(CITIZENS ASSN. FOR SOUND ENERGY)

Mr. Vincent Noonan Nuclear Reactor Regulation Washington, D. C. 20555

During the meeting of 3/23/85 in Arlington, Texas, there was a discussion regarding my concerns with HVAC supports which did not appear to have any bracing for a vertical load from the pipe. I am supplying herewith further information regarding this which I hope will be helpful to the TRT members who are looking into this matter.

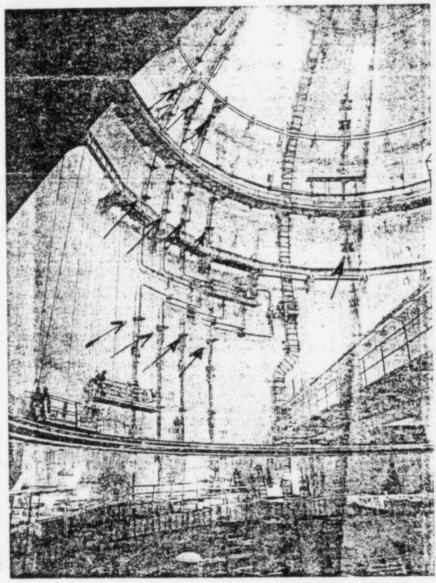
The supports indicated by the red arrows in the attached newspaper armicle appear to be cantilevered supports from the liner in the containment in Unit 1. These supports, cantilevered from the liner, appear not to have any bracing for a vertical load from the pipe; specifically, the vertical load from the pipe or pipe support due to self-weight excitation is not braced in the vertical direction, which appears obvious.

The loads imposed upon the supports either due to an axial restraint or due to thermal expansion of the pipe must be considered, as is readily admitted in Applicants' Motion for Summary Disposition. Friction has to be considered also because four of the piping systems shown in the photograph appear to have thermal loops, which would indicate a thermal problem within the piping system or they would not be there, and these supports (because of the high stiffness because they're so close to the liner) exhibit high

stresses within the plate that is under discussion. With these high stresses in the plate that is under discussion (i.e., a 3/8" plate attached to a liner), one loses the assurance that the supports will operate under a seismic or dynamic load combination.
